Office Action Summary

10/575,258

MIGLI, CARLO

DETAILED ACTION

Annotated Fig. 2

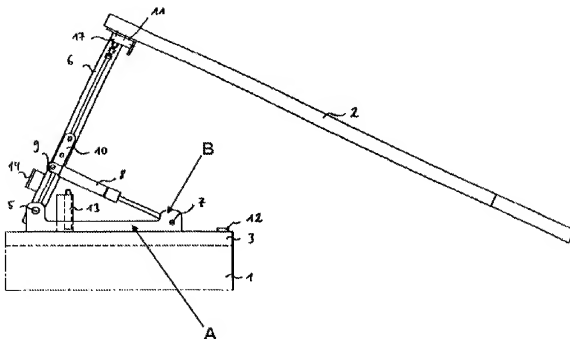
3. For Claim 1, ‘532 discloses a hinge assembly (Fig. 2) for the connection of a vertically opening panel (2) to an element (1) between a closing position (Fig. 1) and an opening position (Fig. 2) comprising:

a supporting base (annotated Fig. 2: A);

a lifting lever (6) operatively connected to the panel (2) and directly hinged to the supporting base (A) about a first pivoting axis (at 5) between said closing and opening positions of the panel;

a balancing device (8) hinged to the supporting base (A) about a second pivoting axis (7) and acting on the lifting lever (6) along a direction of thrust defined by a line joining the second pivoting axis and a point of application of the thrust on the lifting lever to at least partially counterbalance the weight of the panel during rotation of the lever about said first pivoting axis (as seen in Fig. 2);

wherein the second pivoting axis (7) defines with the first pivoting axis (5) a dead center plane (as seen in Figs. 1-2);

wherein the first pivoting axis (5) and said balancing device (8) are positioned above an upper surface (3) of the element (1) in the mounting position of the hinge assembly (as seen in Figs. 1-2);

wherein in said closing position (Fig. 2) of the panel the second pivoting axis (7) is interposed between the panel (2) and the first pivoting axis (5); and

wherein the direction of thrust of the balancing device during operation is never below said dead center plane (as seen in Fig. 2); and

wherein said balancing device (8) comprises an adjustment device (10) for adjusting the thrusting force exerted by the balancing device on the lifting lever.

21. For Claim 11, '711 teaches the hinge assembly according to claim 10, wherein said hollow body (20) is hinged to at least one supporting wall (22) extending laterally to the supporting base (18). Further, '532 discloses the hinge assembly hinged to a supporting wall (annotated Fig. 2: B) extending from the supporting base (A).
